KEYSTONE PIPELINE PROJECT - U.S. PHASE IV (STEELE CITY SEGMENT) PIPELINE ROUTE VARIATION FORM			
1	<b>VARIATION TYPE:</b>		
	Refinement: <input type="text"/>	Reroute: <input checked="" type="checkbox"/>	
	Centerline: <input checked="" type="checkbox"/>	Valve Site: <input type="text"/>	Pump Station: <input type="text"/>
2	<b>LOCATION:</b>		
	Sketch: <input type="text"/> Attached	Pictures: <input type="text"/> See attached.	
	State: <input type="text"/> SD	County: <input type="text"/> Haakon	Quad Map: <input type="text"/> N/A
	Township: <input type="text"/> 4N	Range: <input type="text"/> 20E	Aerial Map: <input type="text"/> See attached map sheet
	Section: <input type="text"/> 10, 15	Centerline: <input type="text"/> 3/26/2010	MP: <input type="text"/> 446.85 to <input type="text"/> 447.47
3	<b>REASON FOR ROUTE VARIATION</b> (Please include reason for route variation):		
<p>The PIs in the current centerline at ~MP 446.8 and ~MP 447.5 were made to square up for road bores at the road crossings. After further investigation, it was found that the road near MP 446.8 and 213th St are two-track field roads and hence will be open cut. This reroute is proposed to eliminate PIs and shorten the

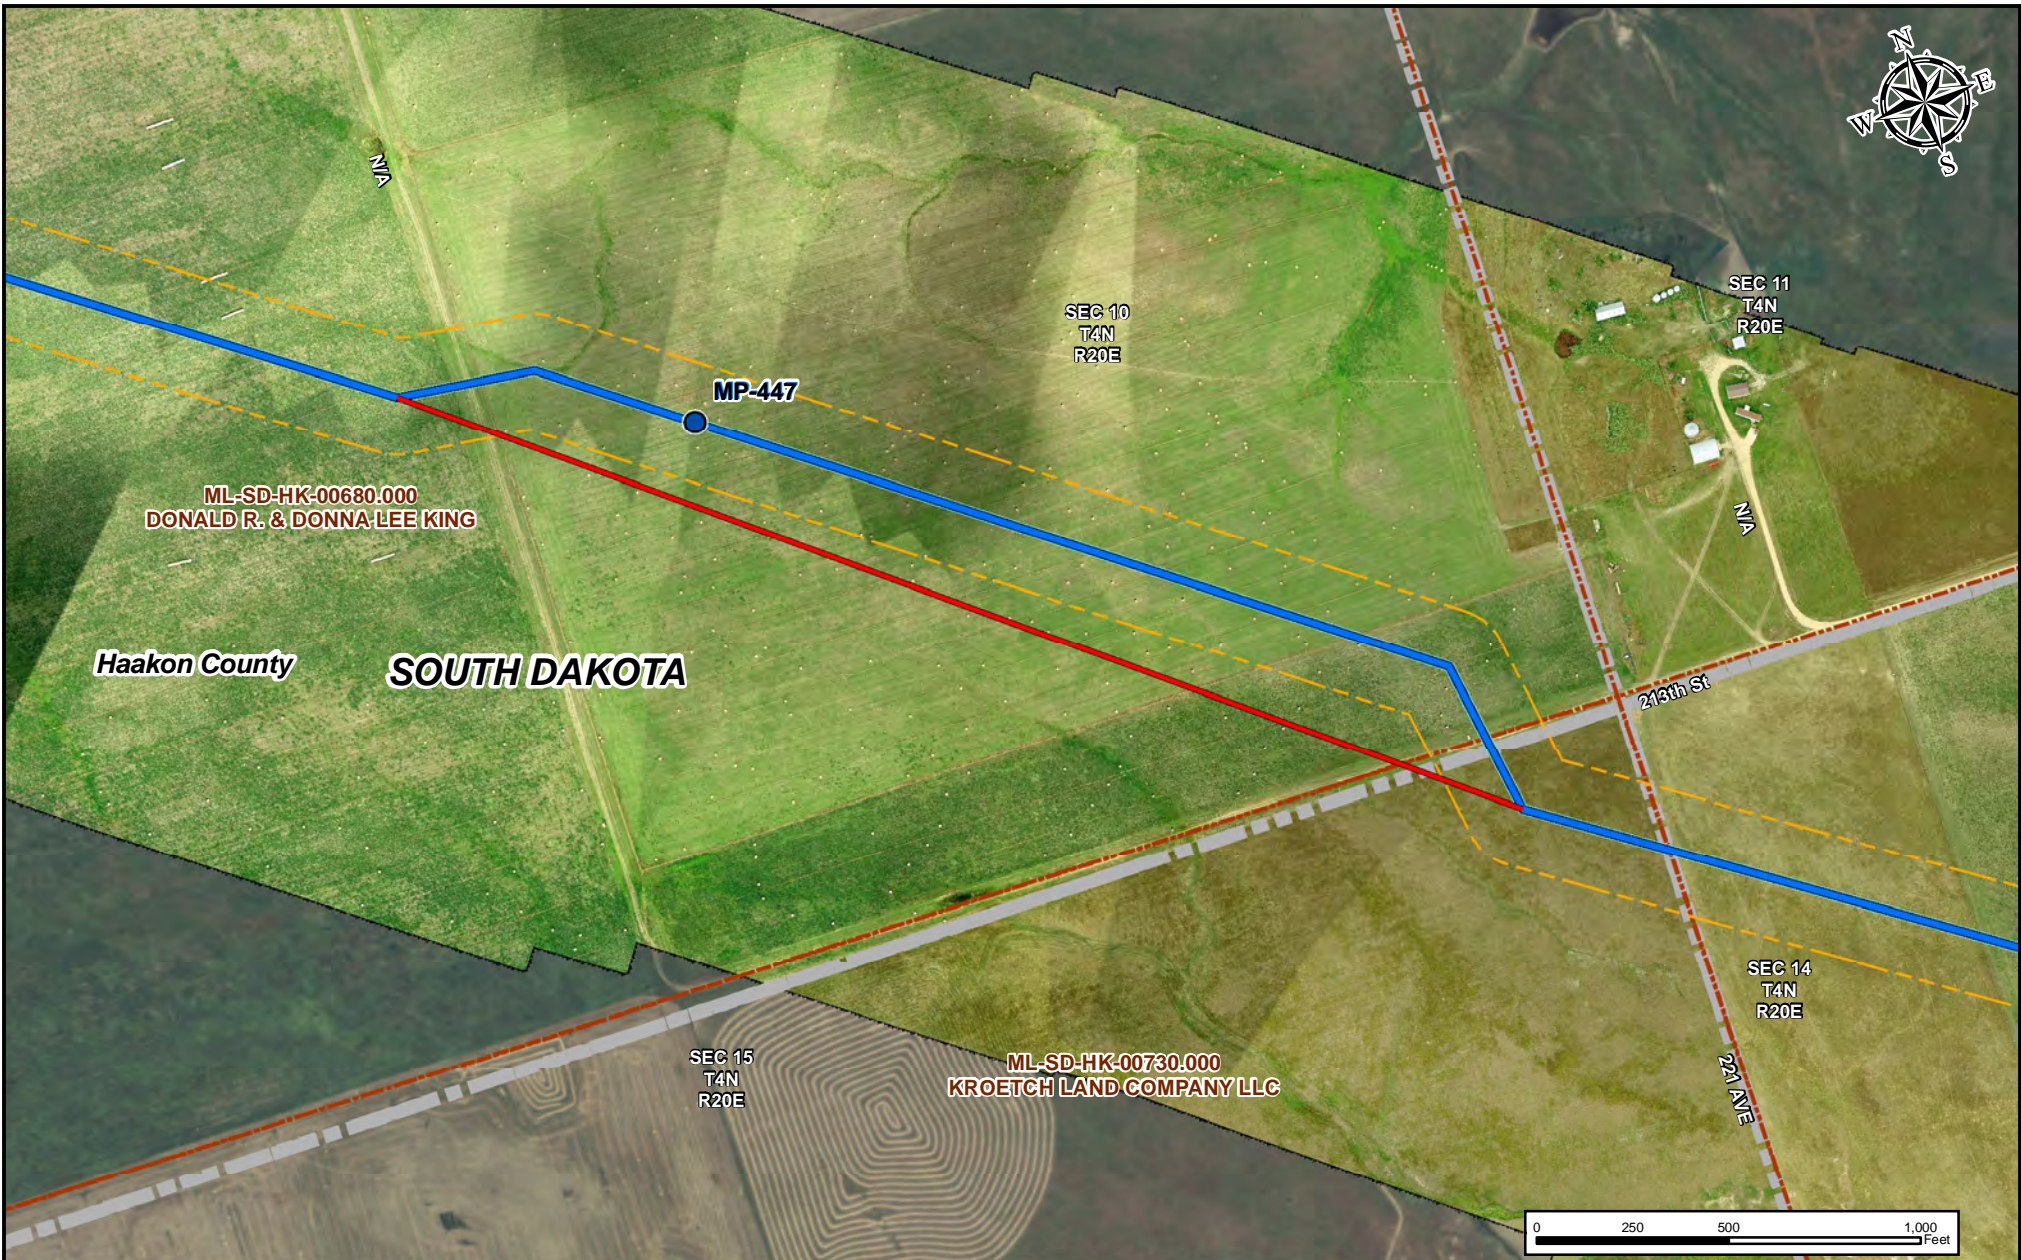
<b>DETAIL ROUTE VARIATION</b> (Please describe route variation in detail):			
<p>The proposed reroute starts at the PI near MP 446.8 and deviates (~30°) from the centerline. It continues in this direction for 3,120 ft to rejoin the current centerline at the PI near MP 447.5.</p>			
<b>ADDITIONAL IMPACTS</b> (Please include any additional impacts which may affect cost; crossings, induction bends, etc.):			
<p>The proposed reroute is 165 ft shorter than the current centerline. It eliminates 4 horizontal fittings, the cost savings for the fittings and their installation is not estimated in the costs below.</p>			
Is there an increase/decrease in the number of crossings? Yes <input type="text"/> No <input checked="" type="checkbox"/>			
If yes, please list: <input type="text"/>			
<b>COST ANALYSIS</b> (costs incurred or saved from the route variation)			
Additional length of route realignment	<input type="text"/> -165	ft.	\$ (59,400.00) \$ 360/ft

<b>Trow - Environmental</b> <span style="float: right;">Jonathan Minton</span> Comments: <input type="text" value="Biological and cultural surveys will need to be completed."/>	Variation: Approved <input checked="" type="checkbox"/> Rejected <input type="checkbox"/> <input type="text" value="Jonathan Minton"/> Date: <input type="text" value="9/24/2010"/> If Rejected Why? <input type="text"/>
<b>Project Management</b> <span style="float: right;">Butch Wallace</span> Comments: <input type="text"/>	Variation: Approved <input checked="" type="checkbox"/> Rejected <input type="checkbox"/> <input type="text" value="R.E. Wallace"/> Date: <input type="text" value="9/24/2010"/> If Rejected Why? <input type="text"/>
<b>Stakeholder Relations</b> <span style="float: right;">Bud Andersen</span> Comments: <input type="text"/>	Variation: Approved <input type="checkbox"/> Rejected <input type="checkbox"/> <input type="text"/> Date: <input type="text"/> If Rejected Why? <input type="text"/>
